APPLICATION NO.	FILING DATE	FIRST NAMED INVENTOR	ATTORNEY DOCKET NO.	CONFIRMATION NO.
10/065,280	09/30/2002	Jeffrey C. Leung	2284.40532	5694
83532	7590	07/28/2010		
ANGIOTECH P. O. BOX 2840 NORTH BEND, WA 98045			EXAMINER DOWE, KATHERINE MARIE	
			ART UNIT	PAPER NUMBER
			3734	
			NOTIFICATION DATE	DELIVERY MODE
			07/28/2010	ELECTRONIC

Office Action Summary	Application No. 10/065,280	Applicant(s) LEUNG ET AL.	
	Examiner KATHERINE M. DOWE	Art Unit 3734

DETAILED ACTION

**FIG. 1G**

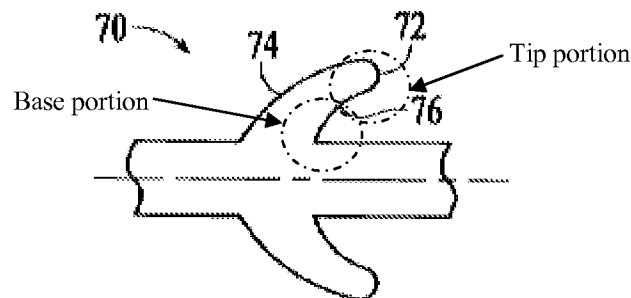
7. Applicant acknowledges Morency teaches an arcuate portion on the underside of the barb. However, Applicant argues the arcuate portion cannot be interpreted as the claimed "base". In response to applicant's argument that the references fail to show certain features of applicant's invention, it is noted that the features upon which applicant relies (i.e., the term

“base” denoting the precise junction between the suture body and the suture barb: in other words, the “base” of the barb referring to the “line” where the barb joins to the suture body - see Applicant's remarks on the second paragraph of page 2) are not recited in the rejected claim(s). Although the claims are interpreted in light of the specification, limitations from the specification are not read into the claims. See *In re Van Geuns*, 988 F.2d 1181, 26 USPQ2d 1057 (Fed. Cir. 1993).

8. The examiner notes the claims merely recite, “...the suture comprising barbs with a configuration that includes an arcuate base at the underside of the barbs...”. Applicant does not provide a special definition of the base, and thus the base may be interpreted as the portion of the underside of the barb adjacent the suture body, as opposed to the tip portion of the barb, wherein the base portion is arcuate. See annotated Figure 1G below:
